**BSR/ASHRAE/IES Addendum ch
to ANSI/ASHRAE/IES Standard 90.1-2016**

Proposed Addendum ch to Standard 90.1-2016, Energy Standard for Buildings Except Low-Rise Residential Buildings

**First Public Review (February 2019)
(Draft Shows Proposed Changes to Current Standard)**

Figure 3.2-5 Computing *daylight area under skylights* in multistory spaces

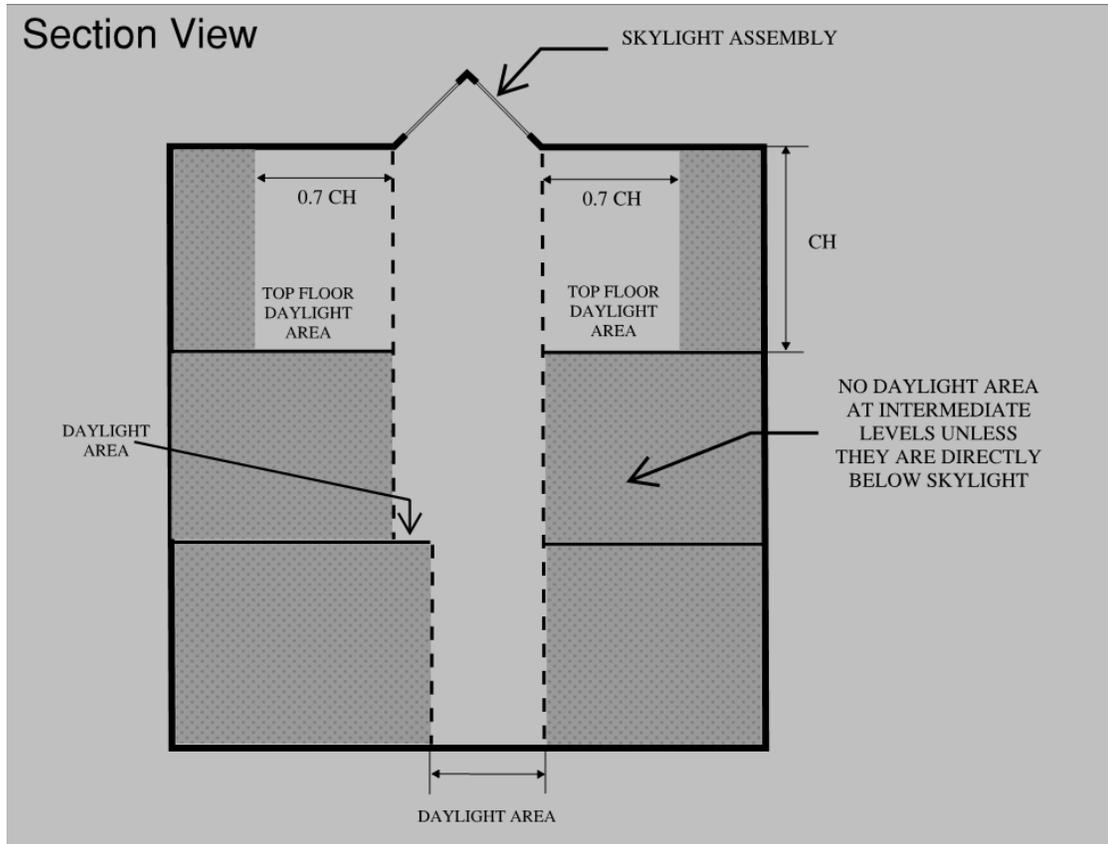
daylight area under skylights in multistory spaces: the *daylight area under skylights in multistory spaces* shall include *floor* areas directly beneath the skylight and portions of the uppermost *floor* adjacent to the multistory space that meet the criteria for a *daylight area under skylights*, where CH is the ceiling height of the uppermost *floor* (see Figure 3.2-5).

Figure 3.2-6 Computing *primary* and *secondary sidelighted areas* with external projections

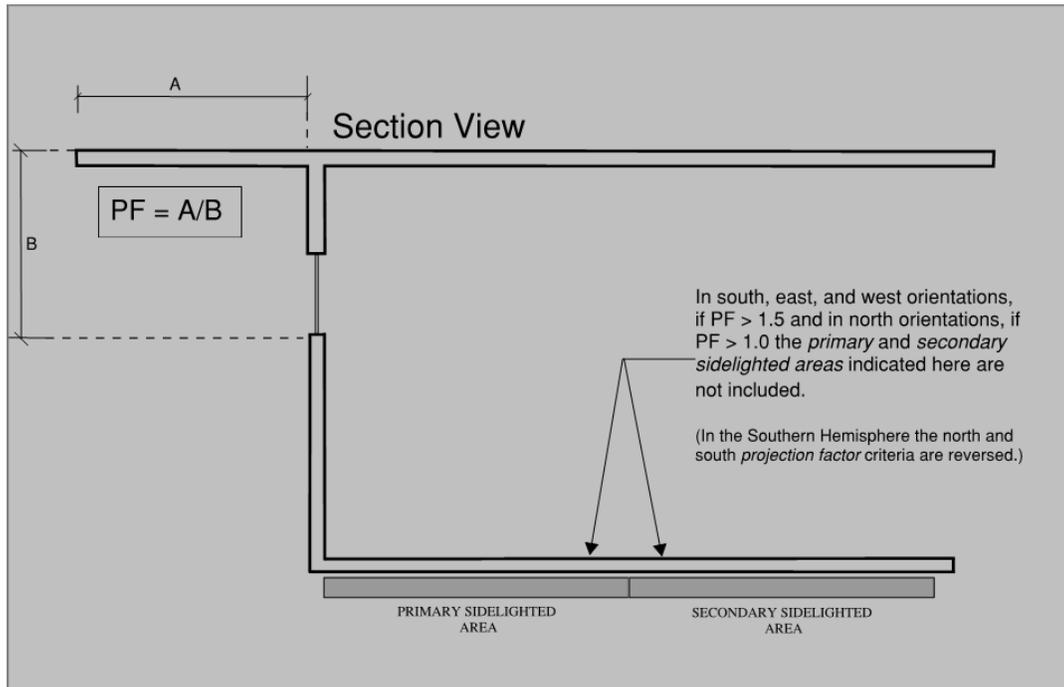
1. Primary sidelighted areas where the top of any existing adjacent structure is twice as high above the windows as its distance away from the windows.
2. Sidelighted areas where the total glazing area is less than 20 ft².
3. Retail spaces.
4. Primary sidelighted areas adjacent to vertical fenestration that have external projections and no vertical fenestration above the external projection, where the external projection

has a *projection factor* greater than 1.0 for *north-oriented* projections or where the external projection has a *projection factor* greater 1.5 for all other orientations (see Figure 3.2-6).
